McClellan Air Force Base

US Air Force Proposes Plan for Interim Remedial Action for PCB Contaminated Soils

June 1993

Figure 2 - McClellan AFB Operable Units

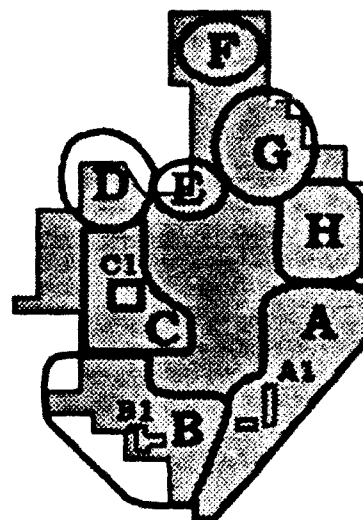
3. Page 3, section 3.1.2 - OUB1. Please include text as to the number of operable units, the chemical contaminants, and expected timeframe for investigation and cleanup. Since this is the first operable unit, a definition should be included as part of this text.

Comment S-3, page 3, section 3.1.2.

Reference to the other operable units as well as a map showing their locations has been added to the Proposed Plan.

Figure 4. Comparative Analysis of Remedial Alternatives

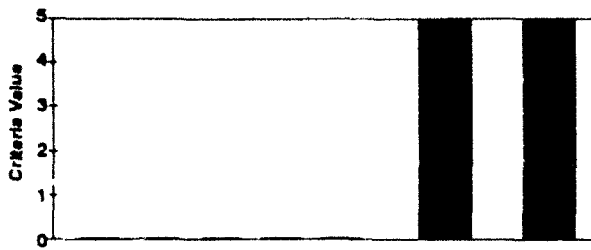
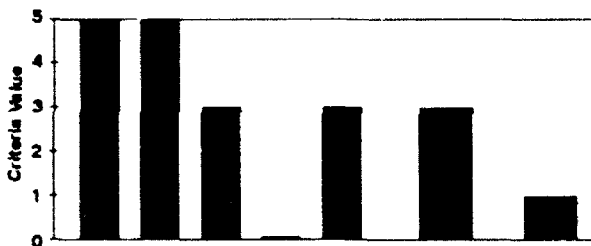
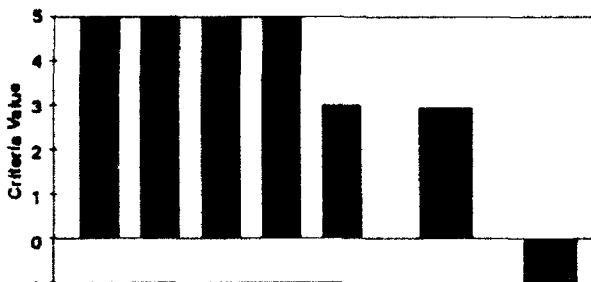
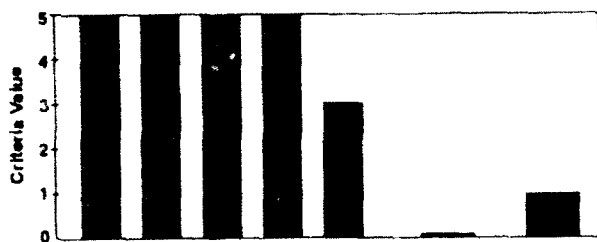
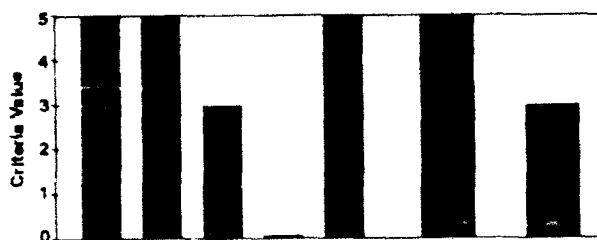
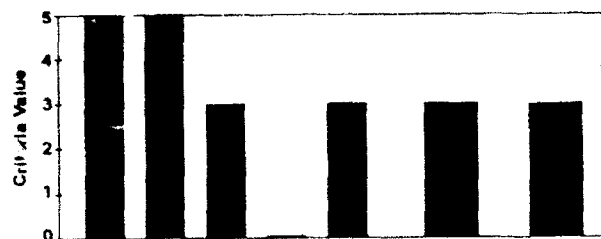
9. Page 10, Section 6.2. Please provide the criteria/numerical value spreadsheet as part of the Proposed Plan.
10. Page 10, Section 6.3. It is the Department's understanding that the entire DRMO lot would be capped and that the capping action would cover all known PCB contamination (not just "contamination at and above 10 ppm.") PCB contamination outside the DRMO area would be excavated and consolidated with the DRMO soils prior to capping.

Comment 9, page 10, section 6.2.

The criteria/numerical spreadsheet has been added to the Proposed Plan.

Figure 4 Conceptual Design for the Capping Alternative

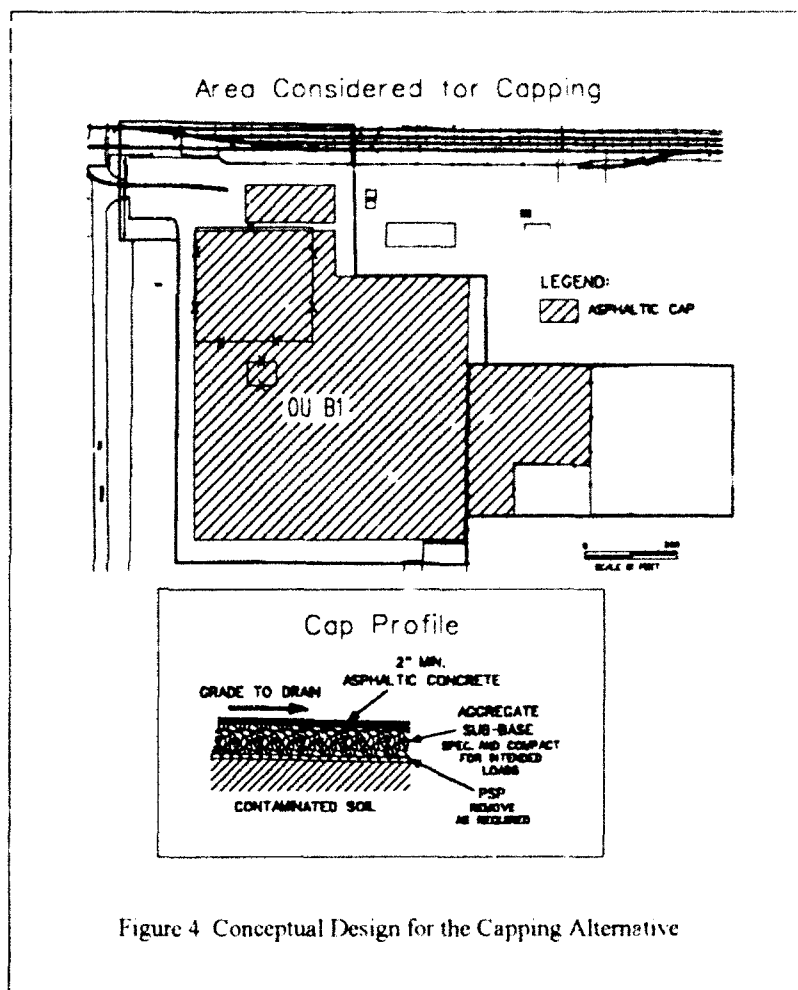
4. Page 6, Column 2, Section 4.4. The Department recommends that McAFB make efforts to consolidate the OU-B1 contaminated soils prior to taking the capping action.

Comment 10, page 10, section 6.3.

The cleanup level for PCBs for OU B1 has been set at 10 ppm. Therefore only areas at or above 10 ppm need be addressed by the selected remedial action. However, another Air Force objective for this project is to keep DRMO in operation. Therefore the entire lot is to be capped, effectively treating all the PCB contamination. The Proposed Plan has been reworded to better explain this reasoning.
